Submission: **SR35-07**

Offshore Special Regulations – 3.08.2

Windows/Hatches in the Side of Superstructures

A submission from the Chairman of Offshore Committee

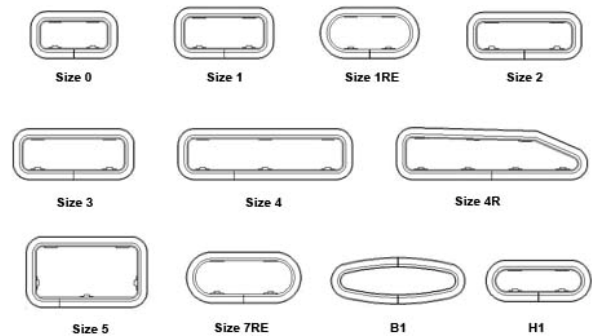
An interpretation was approved last November in regards to hatches/windows in superstructure. The interpretation stated that if the hatches were kept closed they would not be considered as openings and assumed to be part of the superstructure and therefore exempt from 4.08.1. These are now commonly fitted on boats produced by the major large volume manufacturers (e.g. Beneteau, Bavaria, X-Yachts etc.) in the coachroof as windows to make the interior more light and airy and ventilated. The intent of this submission is to make these fittings clearly permitted while keeping control on the structural specification. By making the hatches closed while racing they do not adversely effecting the watertight integrity of the hull.

Below is the sizes of the standard Lewmar hatches which are one of the most common manufacturer of this product. As you can see almost all the hatches are over the maximum permitted area:

<u>3.08.2</u>	<u>A hatch fitted forward of the maximum beam station, located on the side of the coachroof, opening into the interior of the boat, and of area greater than 0.071m² shall comply with ISO12216 design category A and and be clearly labelled and used in accordance with the following instruction: “NOT TO BE OPENED AT SEA”</u> <u>Attention is drawn to SR 3.02.1 “A hull, including deck, coachroof, windows, hatches, and all other parts, shall form an integral, essentially watertight unit and any opening in it shall be capable of being immediately secured to maintain this integrity.”</u>	<u>**</u>
----------------------	---	------------------
